# SERVICE BULLETIN

ENGINE - HP TURBINE ROTOR AND STATOR ASSEMBLY - PROVIDE NEW STAGE 2 HPT AIR SEAL ASSEMBLY - CATEGORY CODE 8 - MOD.ENG-72-0121

# V2500-ENG-72-0121

Before and after views of configuration changes that affect the Stage 2 HPT Airseal Assembly  
Fig.1

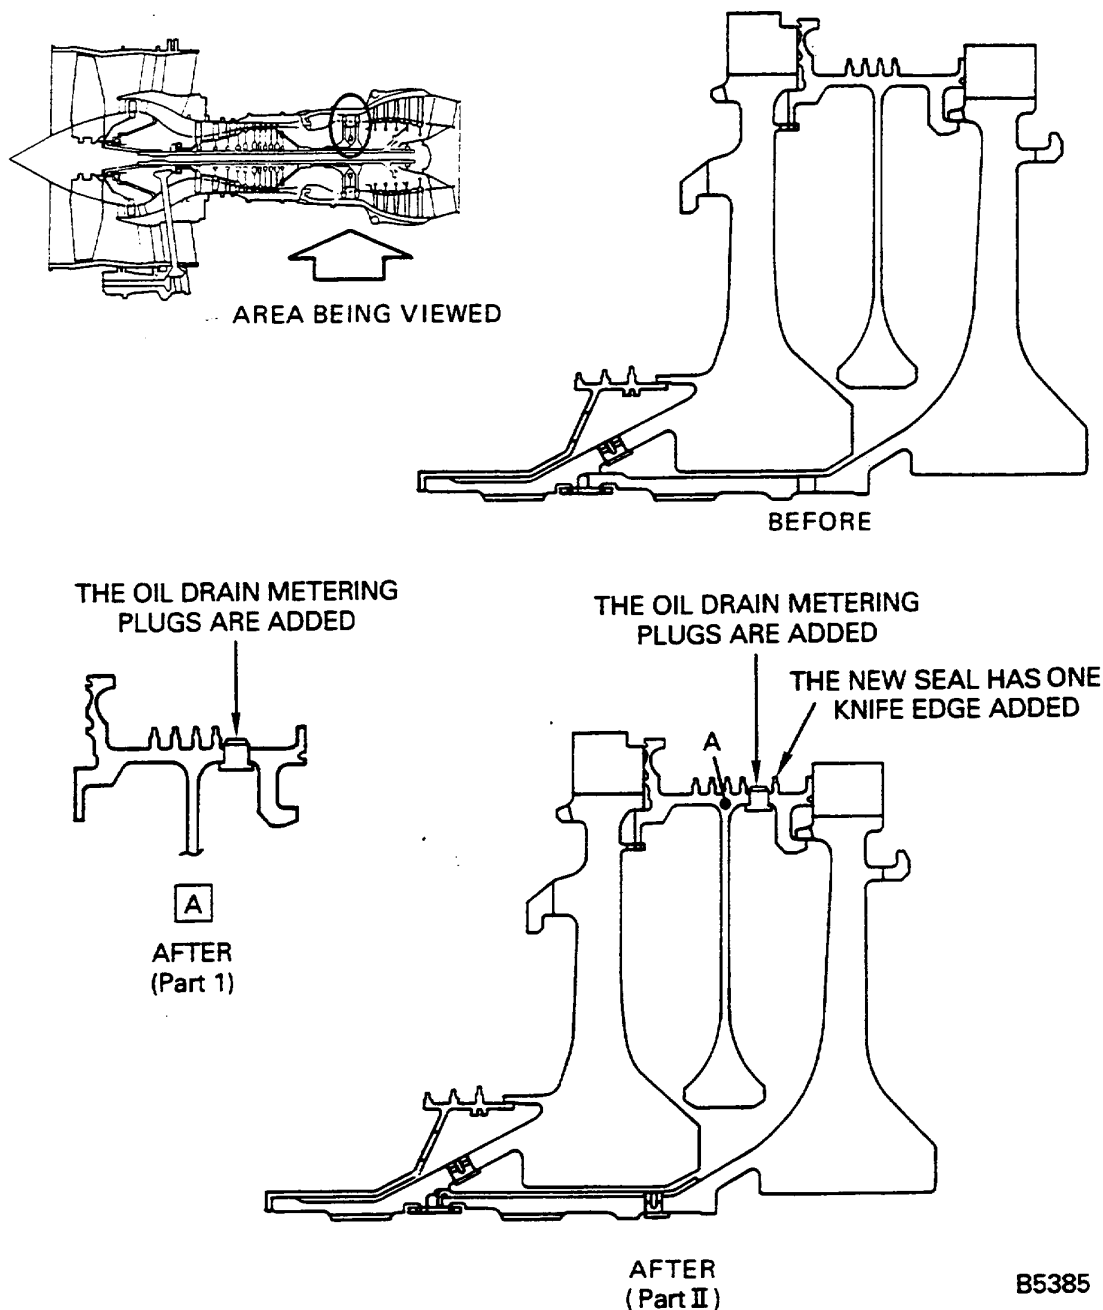
- (a) New oil drain metering plugs are installed in the stage 2 HPT air seal. Refer to Figure 1.

- (a) A new stage 2 HPT air seal assembly which has 5 knife edges and oil drain metering plugs is introduced.
- (2) The modification given in Part 1 is accomplished when the oil metering plugs are installed in the 2A0487 air seal assembly.
- (3) The 2A1158 (2 off) stage 2 metering plugs are necessary to do the modification.
- (4) For the relationship with other Service Bulletins see 1. K. References.

Location of the Stage 2 HPT Air Seal Assembly  
Fig.2

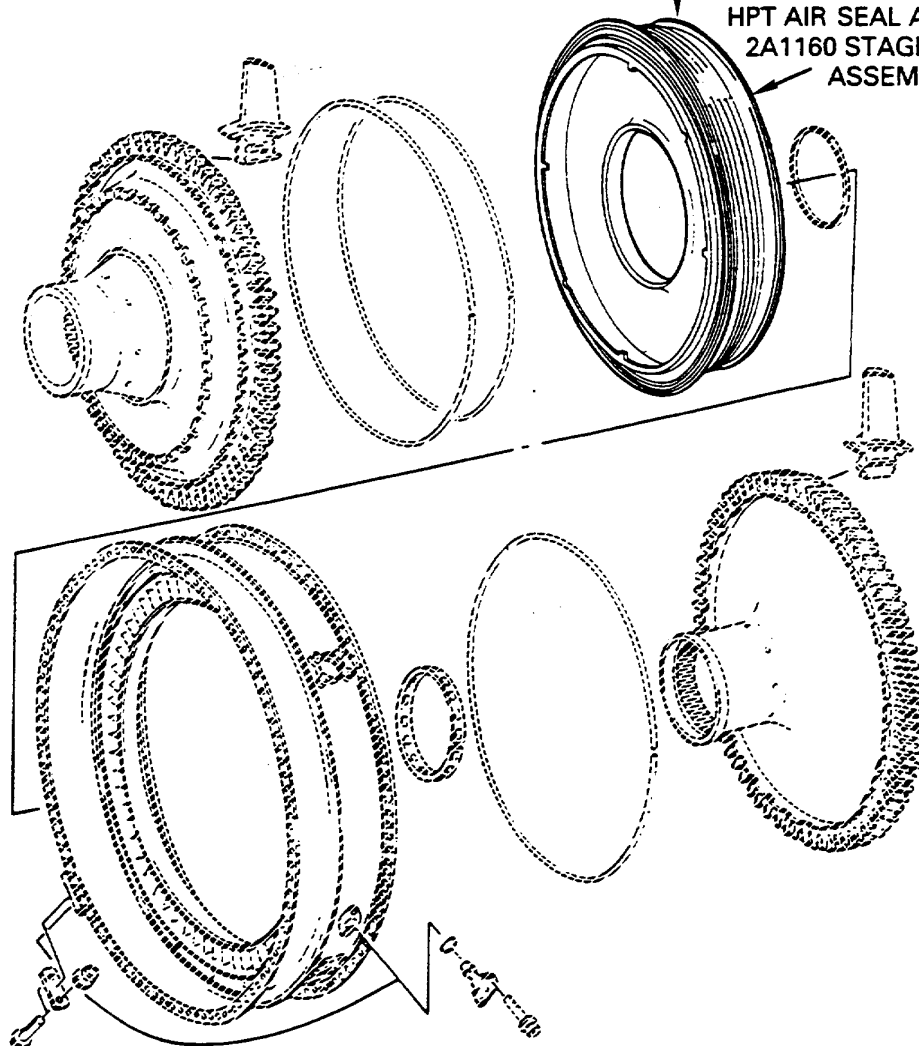
REMOVE THE 2A0487 STAGE 2 HPT AIR SEAL, DO A MODIFICATION, AND INSTALL AS THE 2A1159 STAGE 2 HPT AIR SEAL ASSEMBLY (1 off)

REMOVE THE 2A0487 STAGE 2 HPT AIR SEAL AND INSTALL THE 2A1160 STAGE 2 HPT AIR SEAL ASSEMBLY (1 off)

- (1) Install the 2A1159 Stage 2 HPT Air Seal Assembly (1 off) by the procedure given in Reference (4), Chapter/Section 72-45-00, Assembly-01. Refer to Figure 2.

- (1) Install the 2A1160 Stage 2 HPT Air Seal Assembly (1 off) by the procedure given in Reference (4), Chapter/Section 72-45-00, Assembly-01. Refer to Figure 2.

Modification of the Stage 2 HPT Air Seal Assembly  
Fig.3

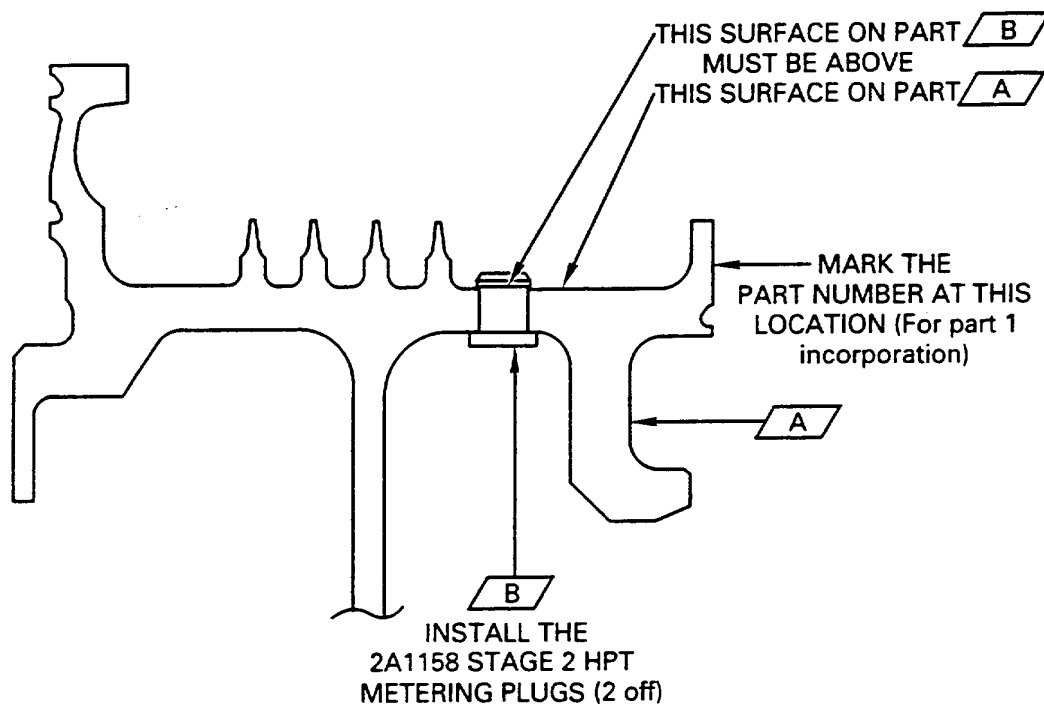
Procedure	Supplementary Information	
(a) Install the two 2A1158 Stage 2 HPT Metering Plugs (2 off) into the Stage 2 HPT Air Seal.	Refer to Figures 2 and 3.	
(b) Mark the new part number adjacent to the old part number. Use the vibration peen method.	Old Part No. 2A0487	New Part No. 2A1159
	See Reference (3), Control No./ TASK No. 70-09-00-400-501. Refer to Figure 3.
